RigiCloud Release Notes - 1.20

Date: July 22, 2026

Quarterly release - 2026-06-01

RigiCloud and Edge Node - v1.19.0:

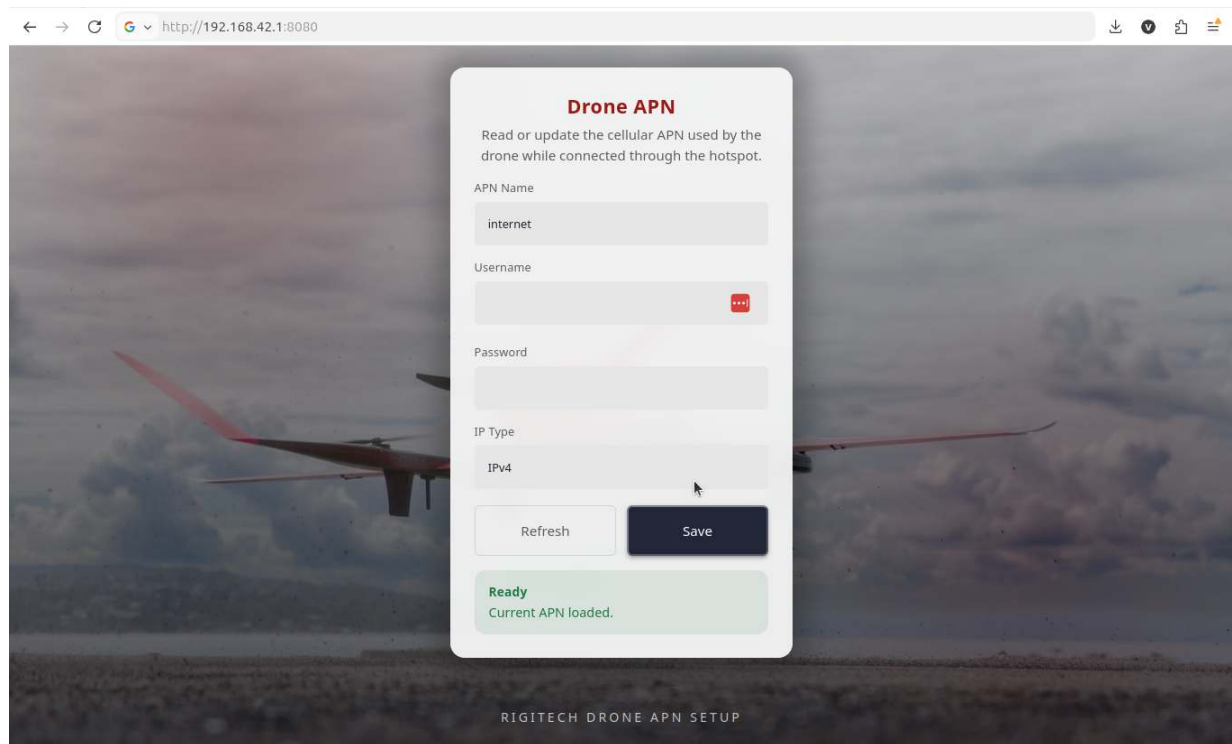
- **Live air traffic:**
 - A new air traffic layer is available from data supplier [SafeSky](#). The data will be available to all clients on a trial basis after release until commercial terms are defined.
 - The **INVOLI** air traffic layer has been deprecated.
- **Enhanced video server:**
 - A new backend for video streaming increases stability and reliability. Support was added for additional external video stream sources within the Control Tower.
- **Improved telemetry display:**
 - Invalid telemetry values now display as '-' instead of '0'.
 - Removed FS LTE link status in Edge Node RigiCloud.
 - **Note:** By design, this information could not be displayed in Edge Node RigiCloud.
